ARKANSAS DEPARTMENT OF ENVIRONMENTAL QUALITY
NOTICE OF INTENT
AGGREGATE FACILITIES
NPDES GENERAL PERMIT ARG500000

From: Robin Rice <robin@alfranksengineering.com>
Sent: Thursday, December 10, 2015 8:17 AM
To: Temple, Jessica
Subject: Fw: ARG500083, Wolf Creek Sand and Gravel Quarry
Attachments: Wolf Creek Sand Site Plan.pdf

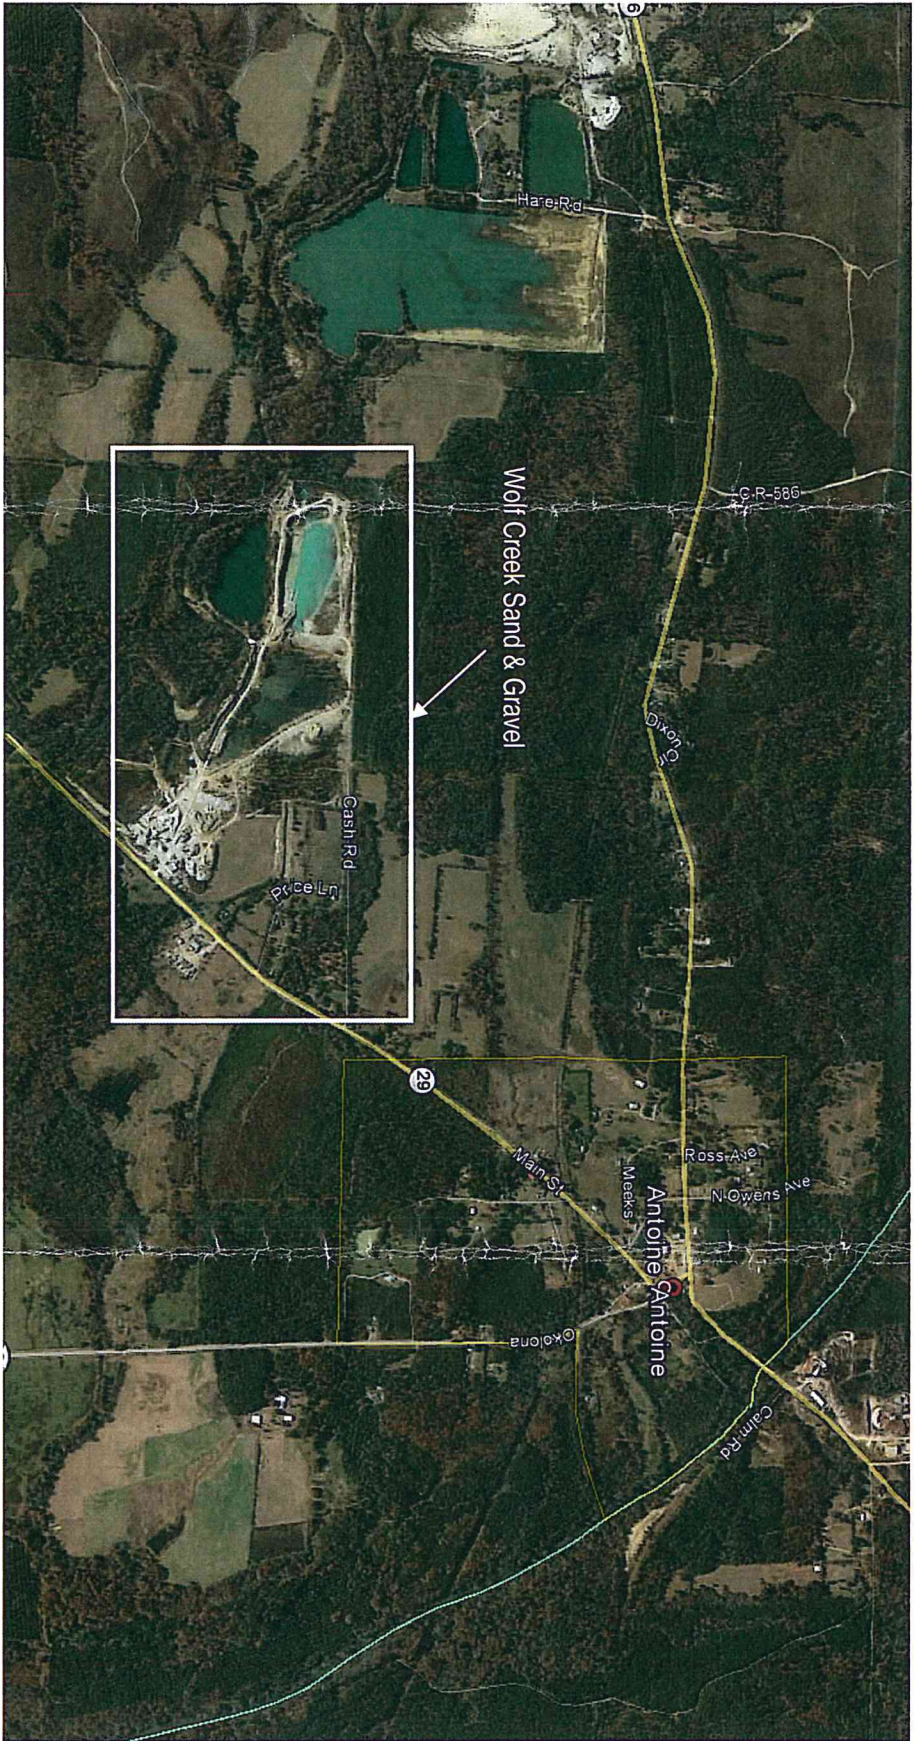
- For the outfall, we need the coordinates for where the outfall would be if the pond were to overflow and have a discharge. If there is no discharge from the pond, they would just mark no discharge on the DMR. And the outfall location needs to be identified on the site map.

- Outfall if the pond were to overflow is 34D 01' 20.75" and 93D 26' 06.26". See attached revised Site Plan.
-
- Also, if stormwater is discharged from somewhere other than the outfall covered under this permit, separate permit coverage may be required under the Industrial Stormwater General Permit.
